State of Hawaii
DEPARTMENT OF LAND AND NATURAL RESOURCES
ENGINEERING DIVISION
1151 Punchbowl Street, Room 221
Honolulu, Hawaii 96813

ADDENDUM NO. 2

Job No. F48C612A
Keaiwa Heiau State Recreation Area Water System Improvements
Aiea, Hawaii

May 19, 2026

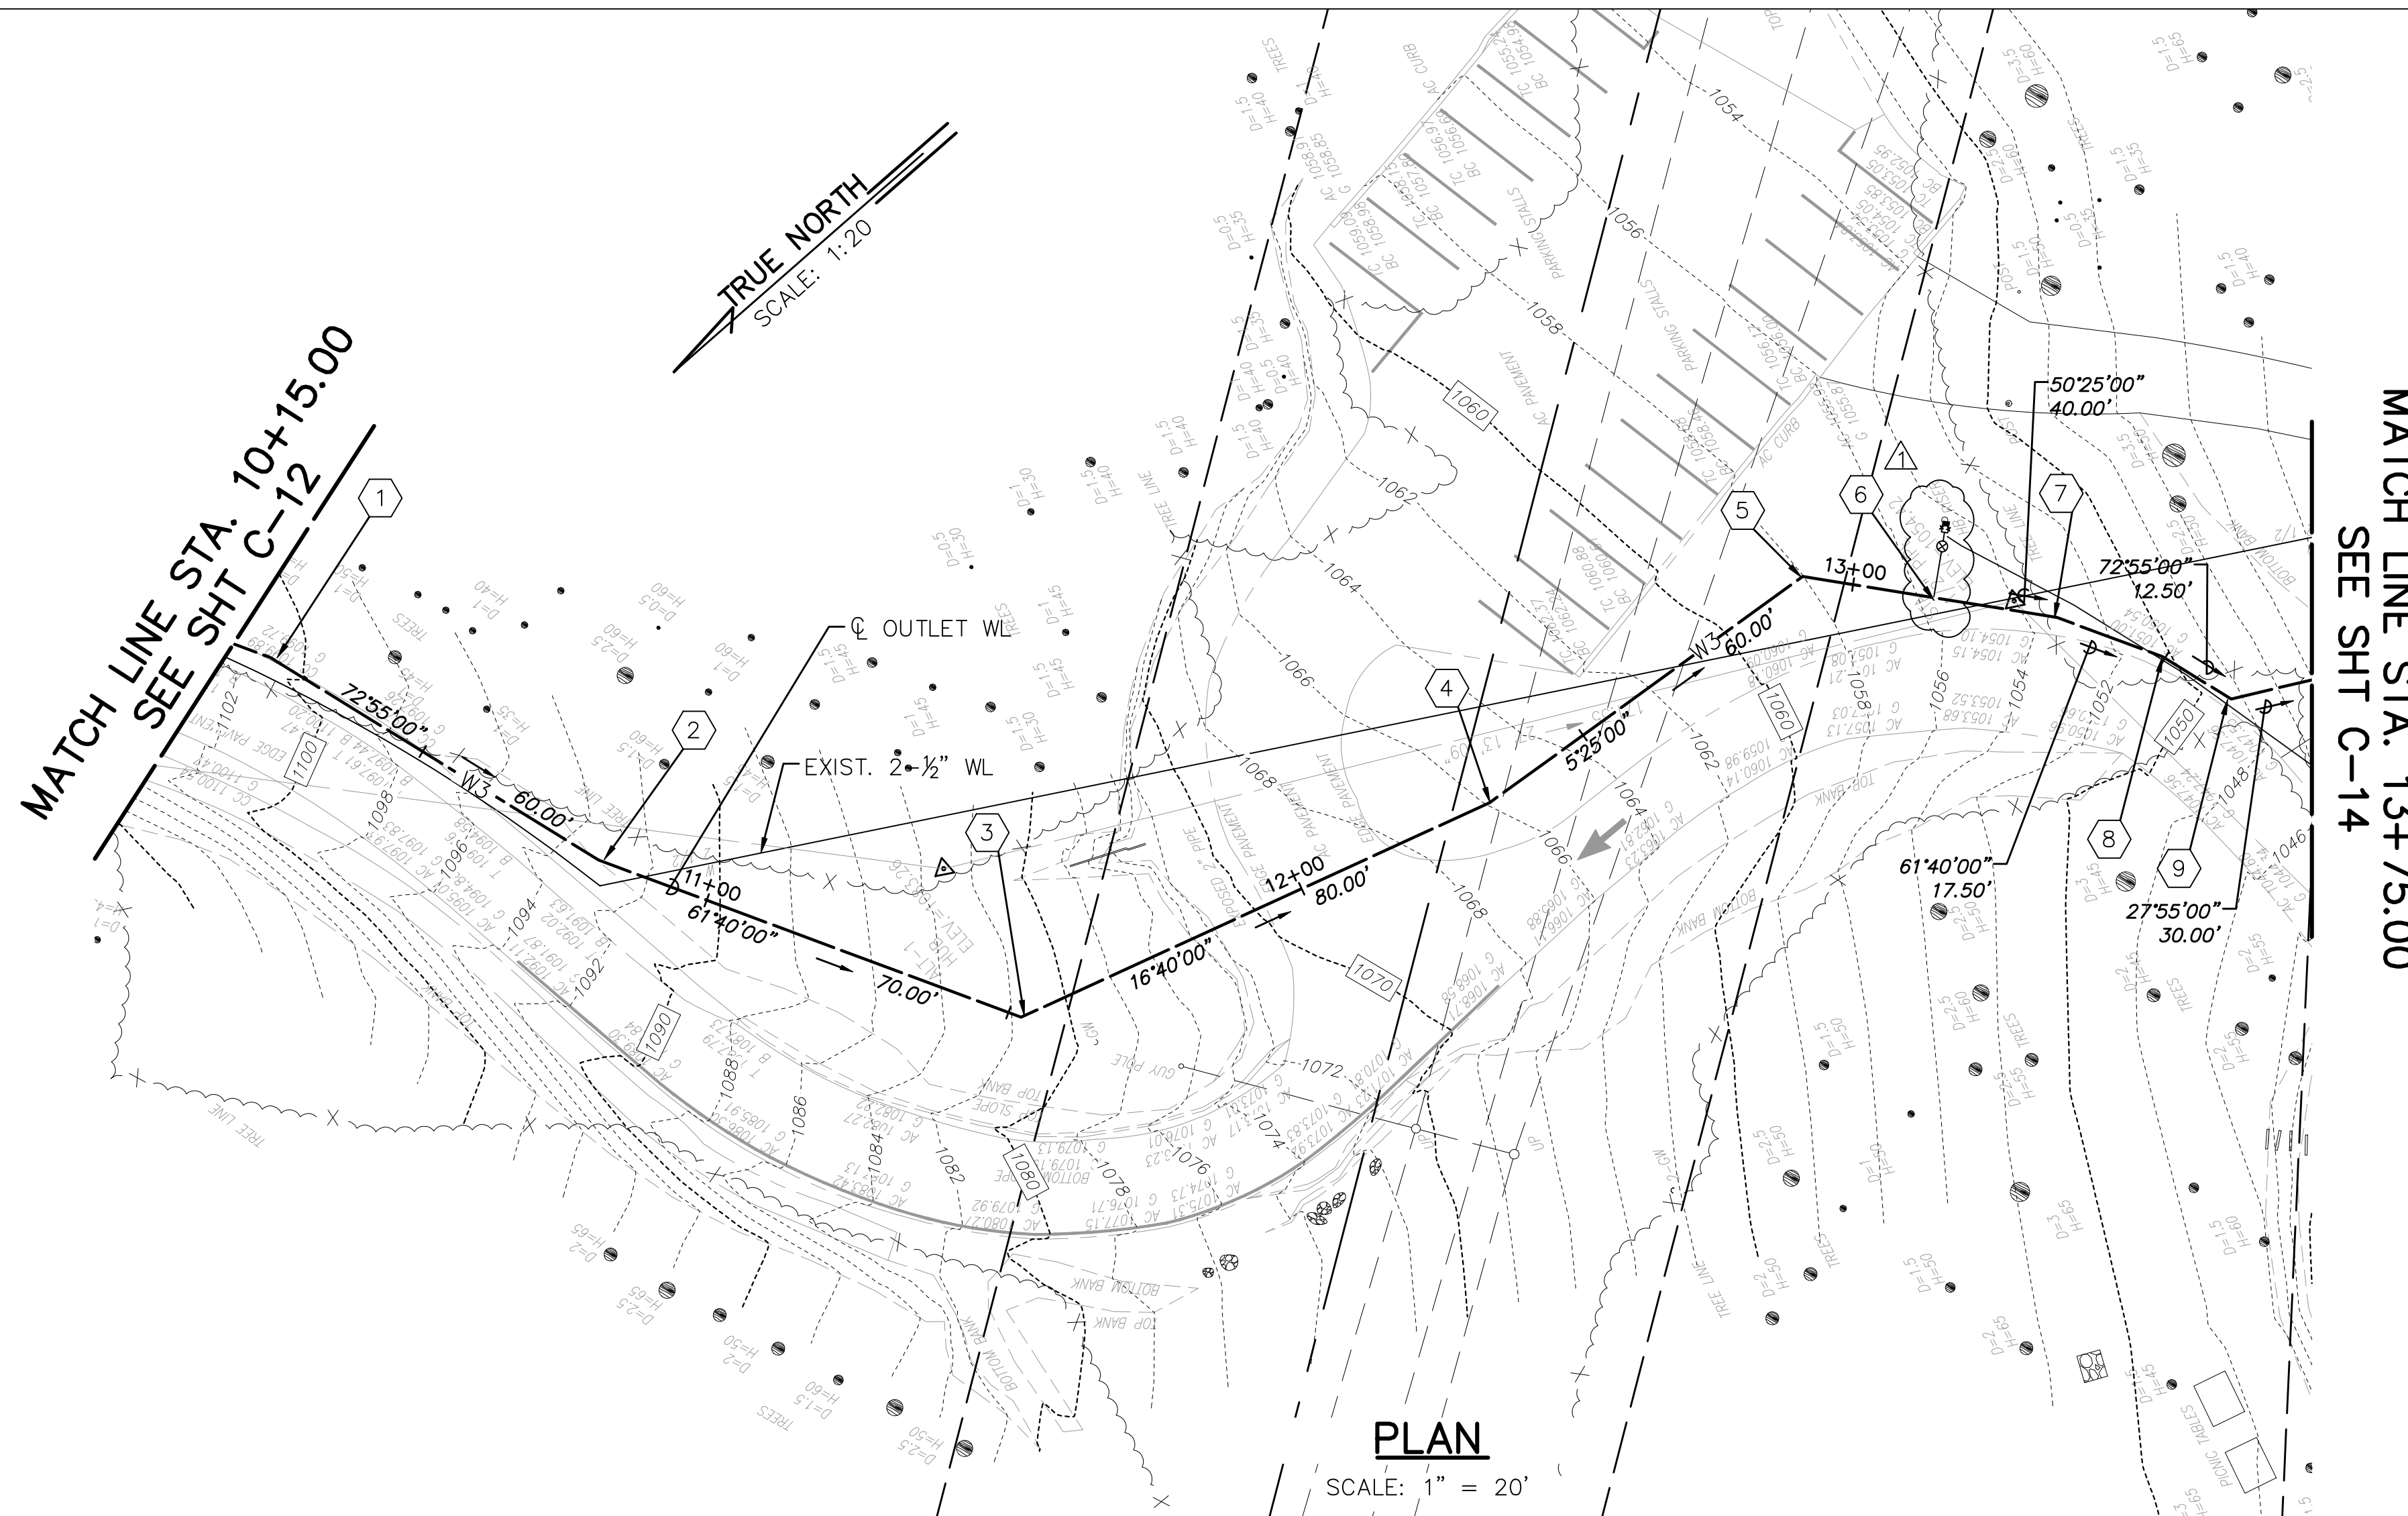
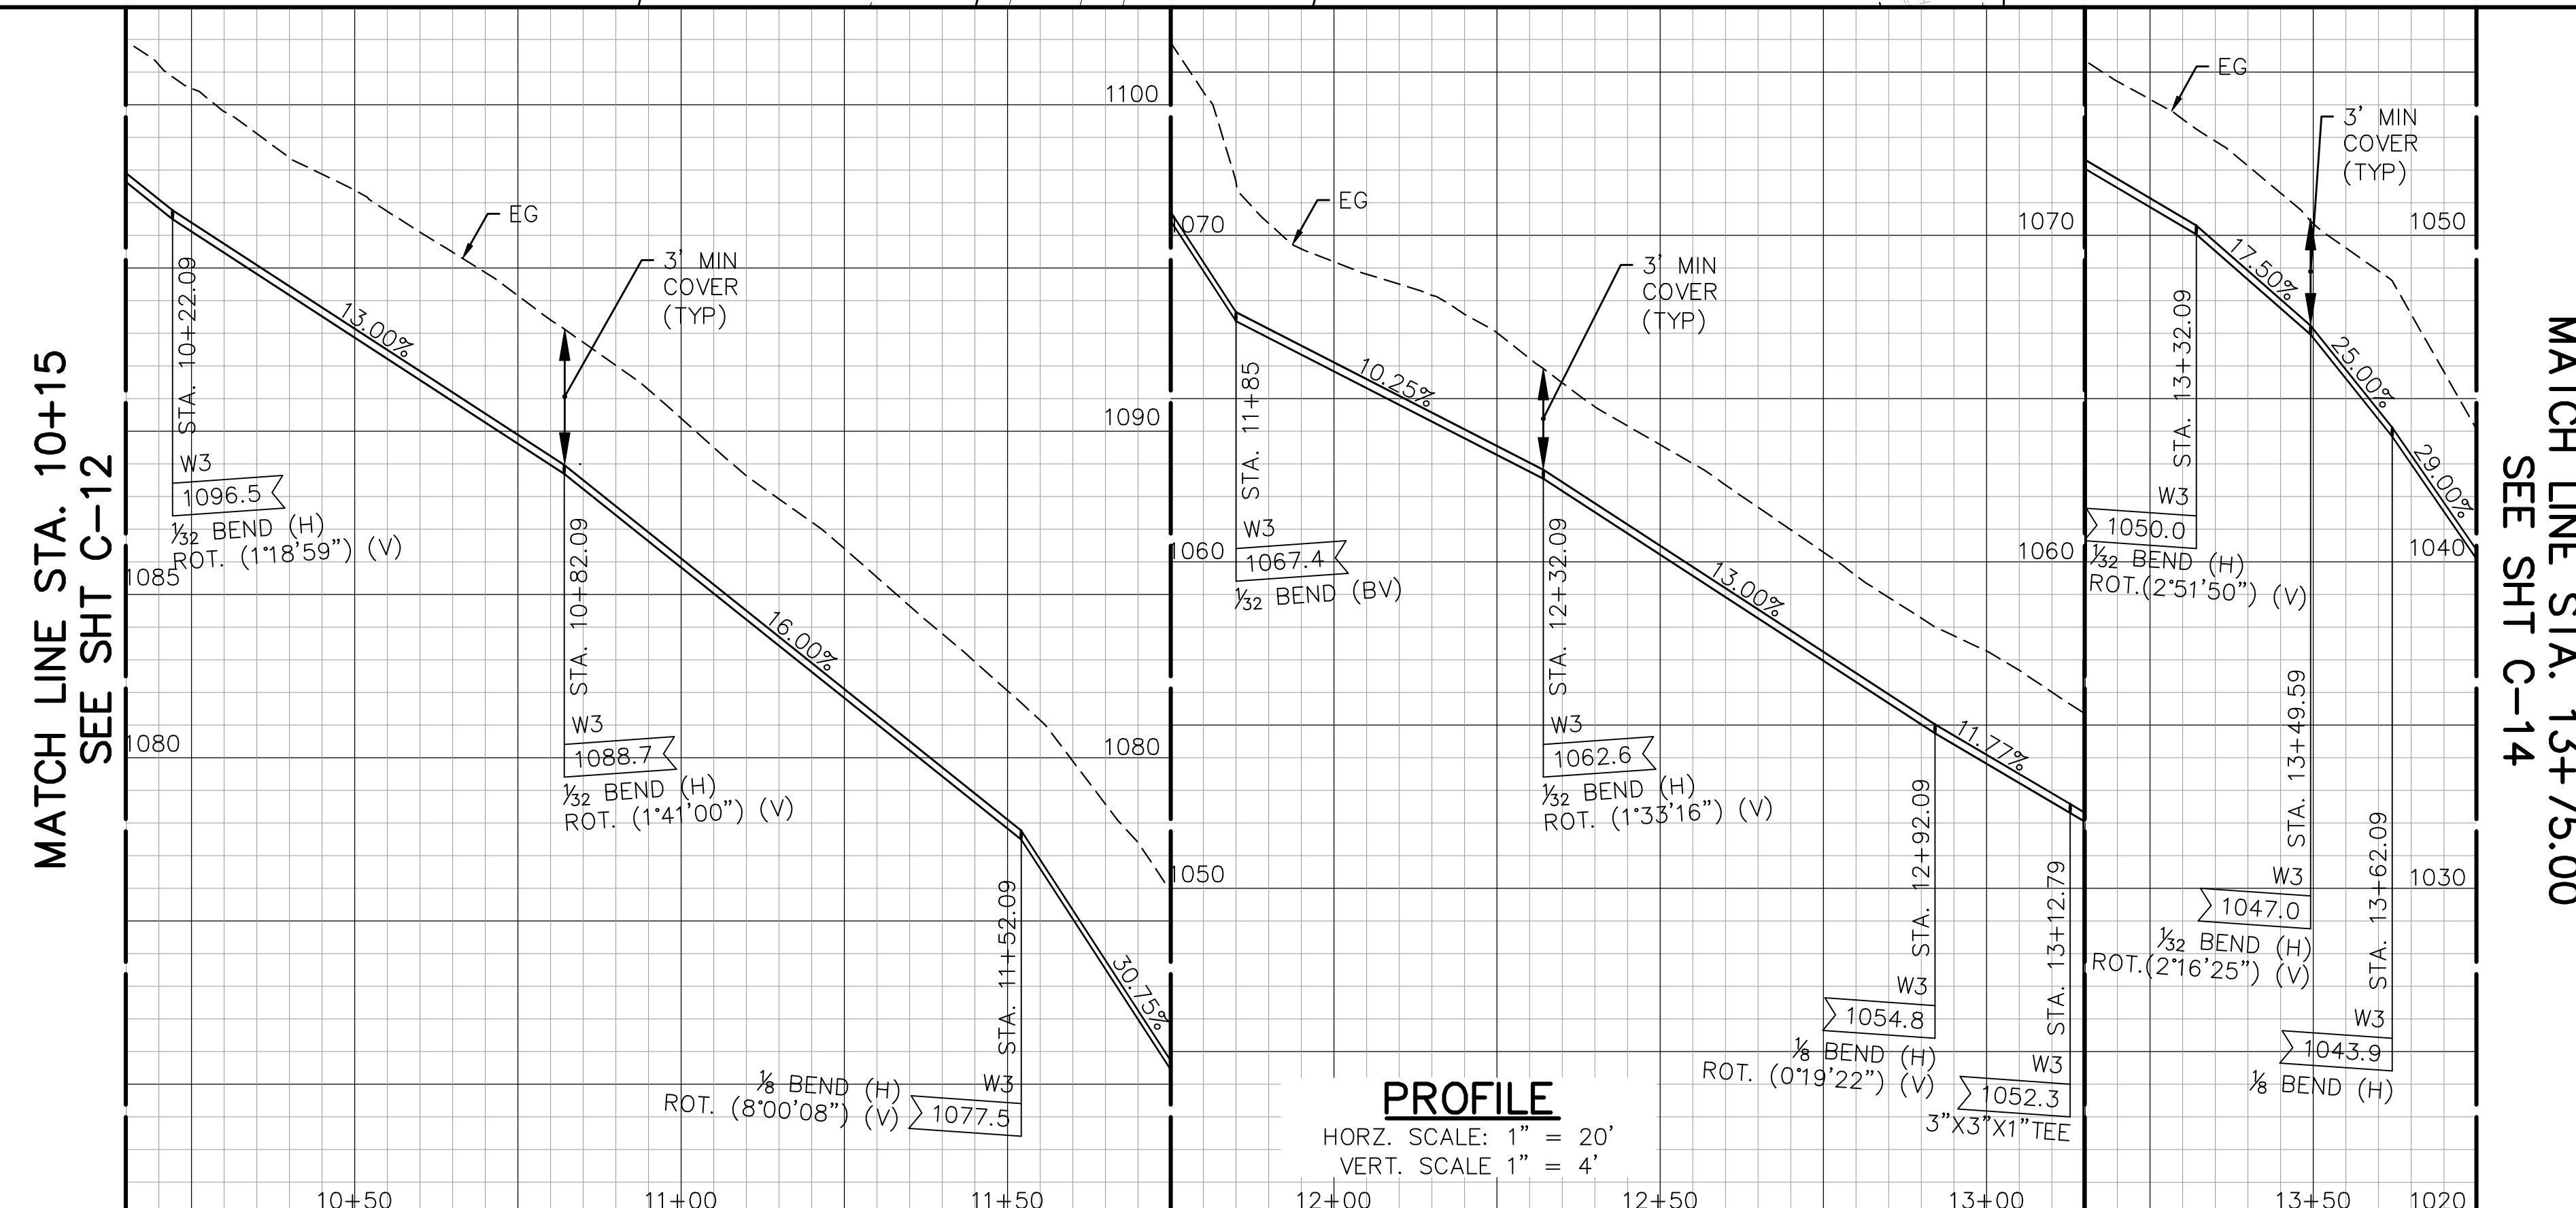
- a. Added new quick coupling valve.
8. Sheet C-13 – Plan & Profile 8, Replace sheet with the attached revised Sheet C-13.
 - a. Added new quick coupling valve.
9. Sheet C-14 – Plan & Profile 9, Replace sheet with the attached revised Sheet C-14.
 - a. Added new quick coupling valve.
10. Sheet C-15 – Water Details, Replace sheet with the attached revised Sheet C-15.
 - a. Added new detail.
11. Sheet C-16 – Water Details 2, Replace sheet with the attached revised Sheet C-16.
 - a. Revised Tank Building Layout Detail
12. Sheet S-2 – Tank Enclosure Building, Replace sheet with the attached revised Sheet S-2.
 - a. Revised Building Foundation Plan.
